SERVICE BULLETIN

M-1243

2009 TOURING MODEL JIFFY STAND BRACKET LEAN ANGLES

Figure 1. OE Identification Marking on Bracket

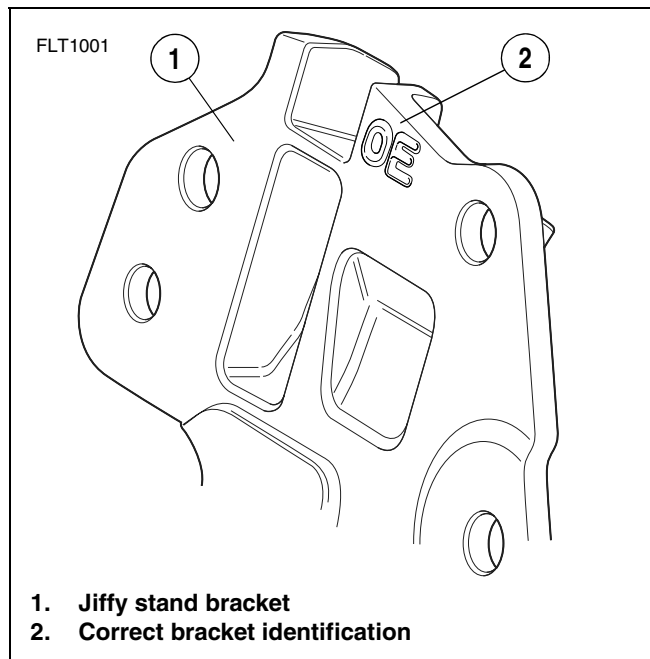
1. See Figure 1. Inspect for the OE embossing (can be felt by reaching behind on back of jiffy stand bracket).
2. Replace with a 50096-09 bracket ONLY if the OE embossment cannot be seen or felt, and the customer requests replacement.
3. If the bracket is to be replaced, perform the required procedure according to instructions in the appropriate model service manual.

The parts catalog is correct. Use normal ordering process. Replace with 50096-09 jiffy stand bracket.
